ADDENDUM: B/SM 59/21: REFURBISHMENT OF THE ROZENDAL RESERVOIR

ADDENDUM NO.1

*"PSG8-22 316SS Access ladder: Temporary removal, pressure cleaning,Unit: Sum
storing, and reinstatement after repair work*

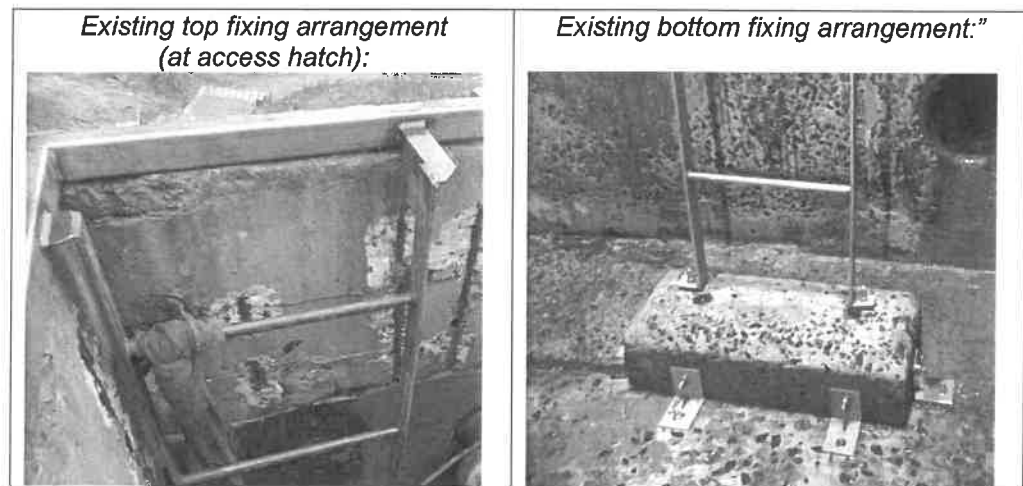
4.3.4 On page C3.4-22 add the following after item PSG8-21:

The tendered rate shall include all costs for any modifications necessary to the ladder to fix the ladder to the reservoir floor, wall and access hatch. For pricing purposes it shall be assumed that the ladder has six individual points of connection to the reservoir wall, with similar bolting arrangement as shown below for the existing floor fixing arrangement.
